Subject: MHI's Response to US-APWR DCD RAI No. 71-986

References: 1) "Request for Additional Information No. 71-986 Revision 0, SRP Section: 03.06.02 – Determination of Rupture Locations and Dynamic Effects Associated with Postulated Rupture of Piping," dated September 9, 2008

Response to Request for Additional Information No. 71-986, Revision 0

US-APWR Design Certification

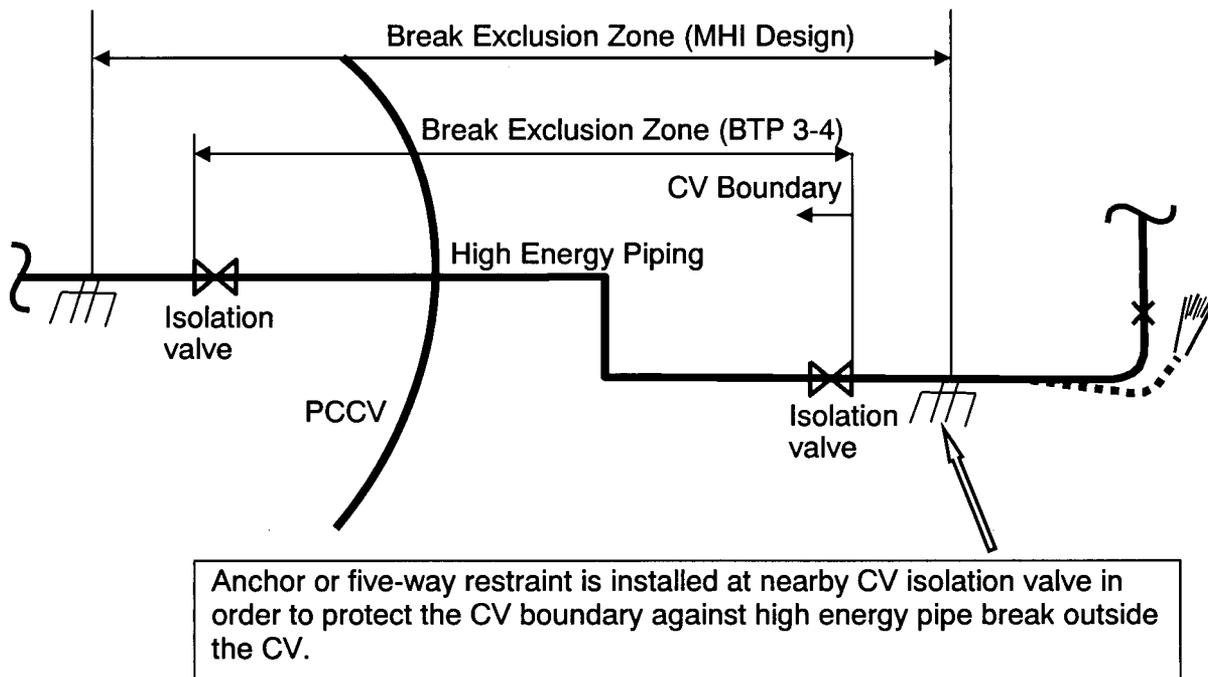
- (e) BTP 3-4, Part B, Item A(ii)(5) states that welded attachments, for pipe supports or other purposes, to the break exclusion portion of piping should be avoided. Where welded attachments are necessary, the welds are 100% volumetrically examinable and detailed stress analyses are performed to demonstrate compliance with the limits of A(ii)(1). It appears to the staff that Item (5) in the DCD Section is consistent with these BTP requirements. However, DCD Figure 3.8.1-8 showing both mechanical and electrical penetrations in the containment design indicates welded connections between the thickened pipe and the end cap attached to the extended containment sleeve. Clarify if these welds satisfy the criteria described above.

- (e) Welds of PCCV penetrations for high-energy fluid system piping which is located between the inner side of flat heads and pipes do not satisfy the criterion of BTP 3-4, Part B, Item A(ii)(5). Therefore, these penetrations will be modified with welded attachments to the flued head structure to satisfy the criterion of BTP 3-4, Part B, Item A(ii)(5). BTP 3-4, Part B, Item A(ii)(5) is applicable only to high-energy fluid system piping penetrations and therefore is not applied to moderate-energy fluid system piping penetrations and electrical penetrations.

(e) The structural explanation in Subsection 3.8.1.1.4 for the penetrations of main steam piping, feedwater piping, and SG blow down piping will be modified from structure with welded attachments to the flued head structure.

The penetration structure for high-energy fluid system piping in Figure 3.8.1-8 will be modified to the flued head structure.
